Shannon Palmer  
Hingham Conservation Commission  
210 Central Street  
Hingham, MA 02043

Response To DEP Comments -6 Accord Lane

6 Accord Lane  
Hingham, MA

6 Accord Lane, Hingham, MA  
Buffer Mitigation

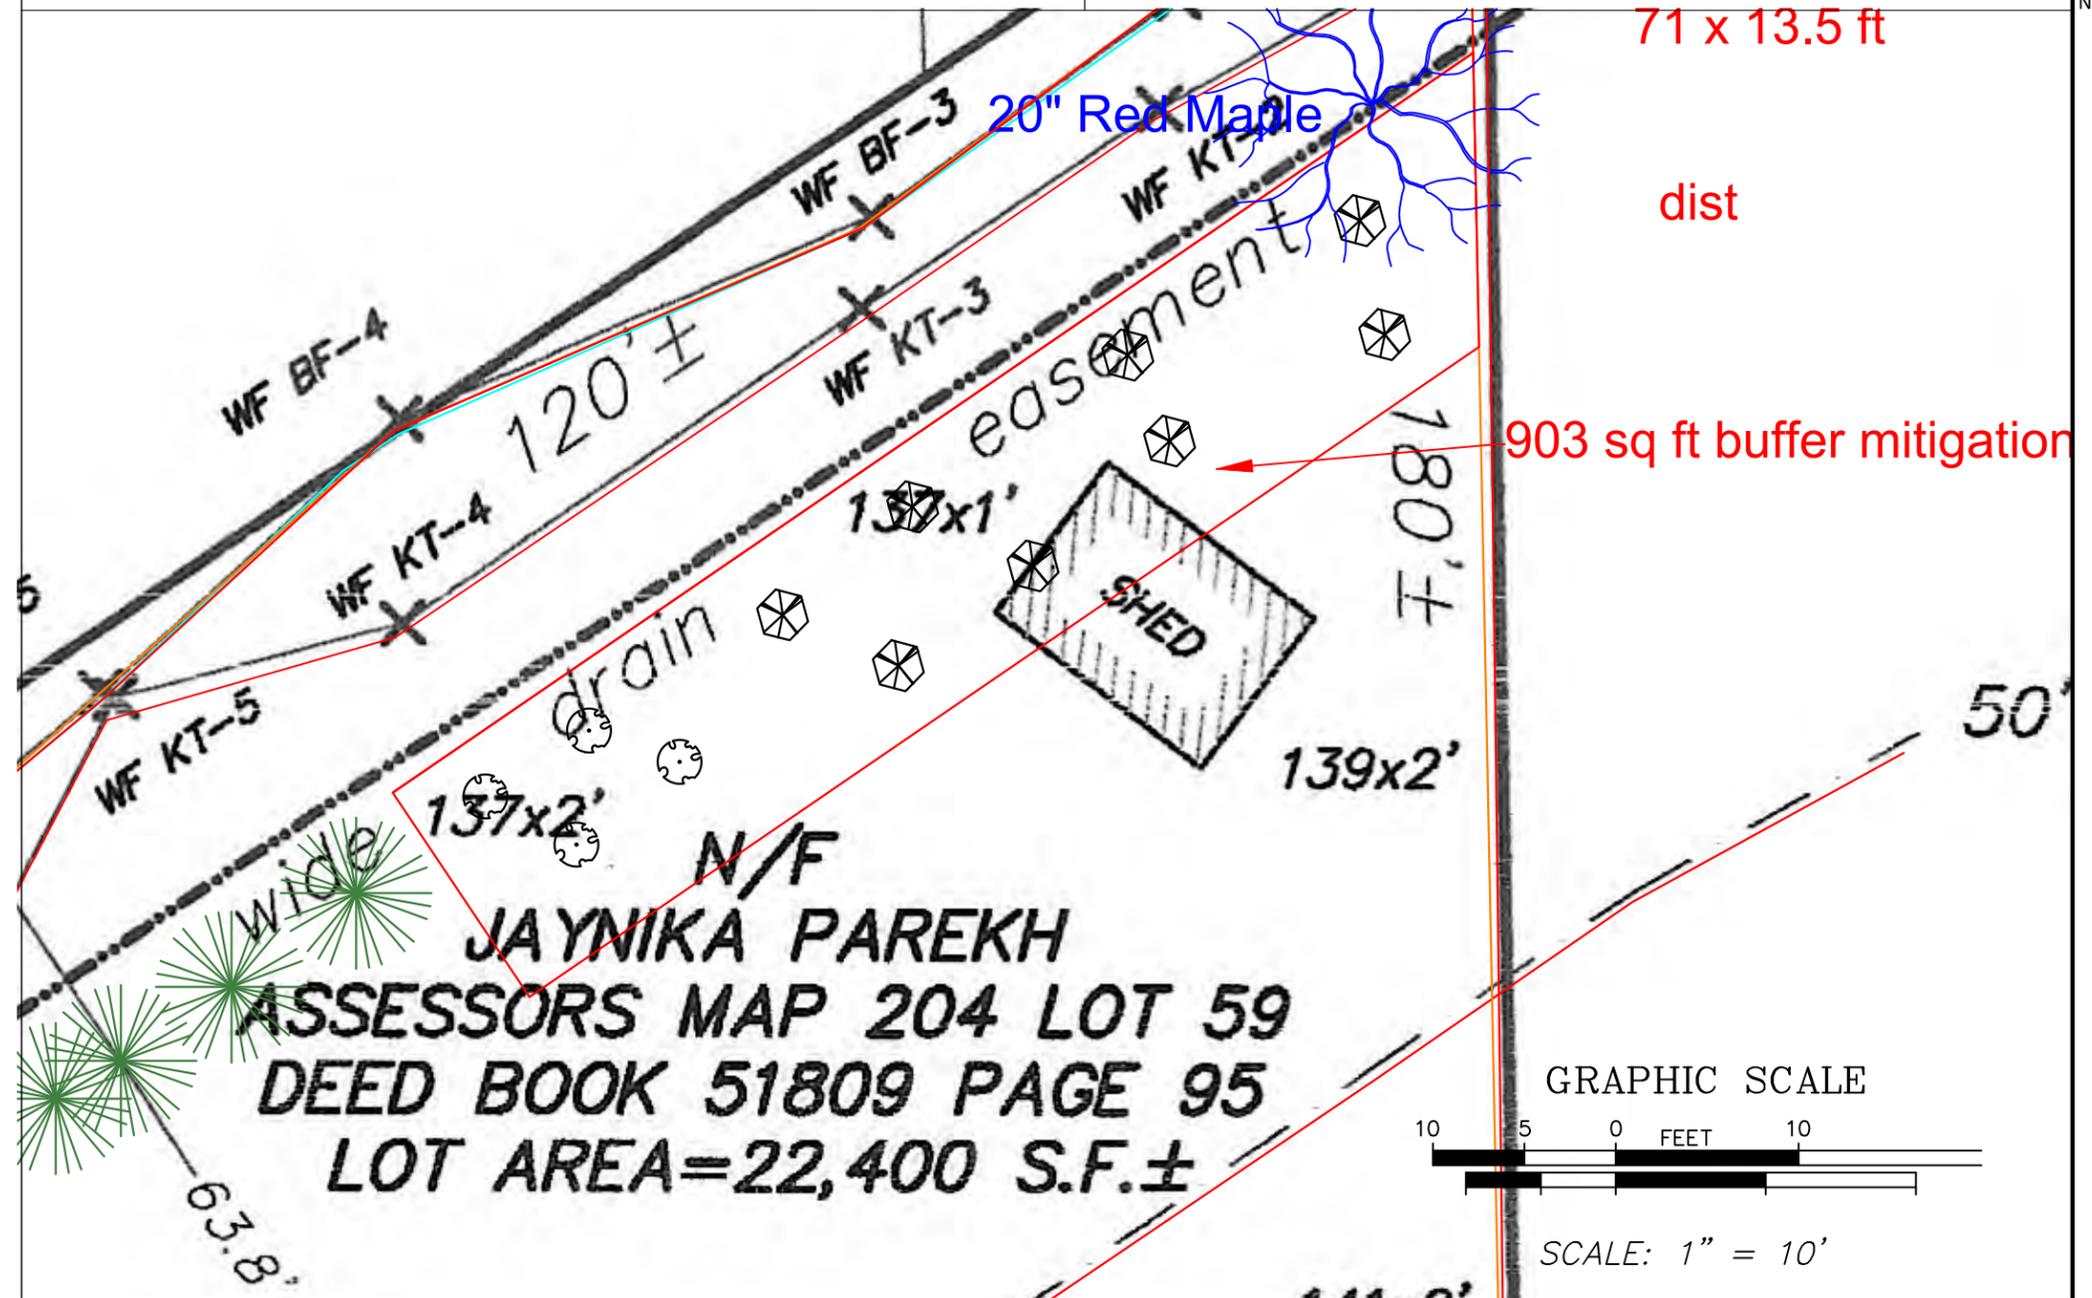
3. coverage by topsoil at a depth consistent with natural conditions at the site; and seeding and planting with an erosion control seed mixture, followed by plantings of herbaceous and woody species appropriate to the site;

***The project will remove the existing driveway 1096 sq ft), which will be loamed and seeded as lawn. Additional mitigation consists of a 903 square foot native planting, see attached mitigation plan. Proposed mitigation within riverfront is 1999 sq ft. The proposed additional impact to riverfront of 1367 sq ft. A reduction of 632 impervious within riverfront.***
